**DHCD Workgroups 3 and 4 Meeting
2012 USBC IRC, IPC, IMC, IFGC, NEC, State agencies related
regulations and MOA's update overview final approval of code changes
Henrico County Training Center 9:30 to 3:30
January 10, 2013**

Code Change Form for the 2012 Code Change Cycle

TABLE R502.5(2)
GIRDER SPANS^a AND HEADER SPANS^a FOR INTERIOR BEARING WALLS
 (Maximum spans for Douglas fir-larch, hem-fir, southern pine and spruce-pine-fir^b and required number of jack studs)

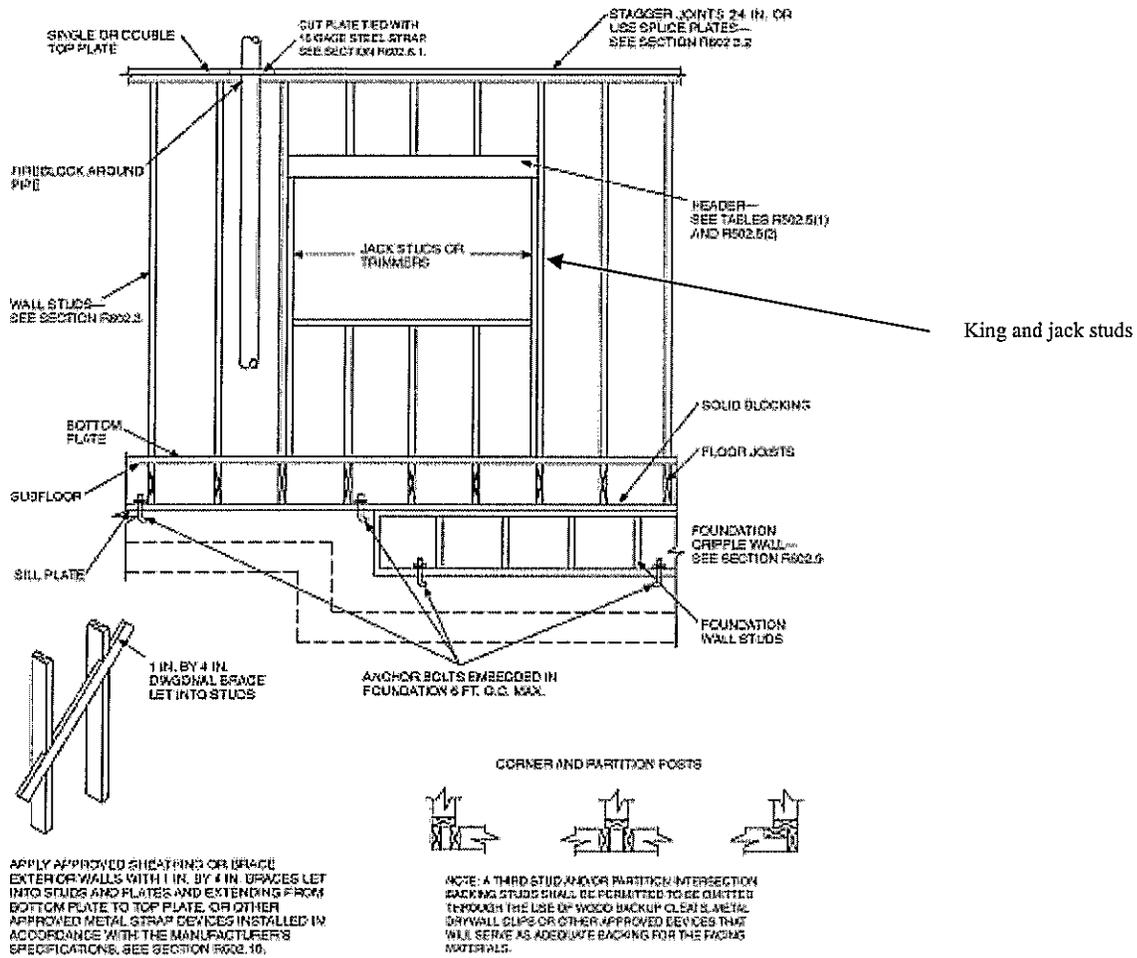
1. Add new section as follows:

R602.7.4 Supports for headers. Headers shall be supported on each end with a jack stud in accordance with Table R502.5 (1) or Table R502.5(2). A king stud as shown in Figure R602.3(2) shall be adjacent to the jack stud(s) on each side and nailed to each end of the header with (4) 16d nails .

5. Modify Figure R602.3(2) as follows:
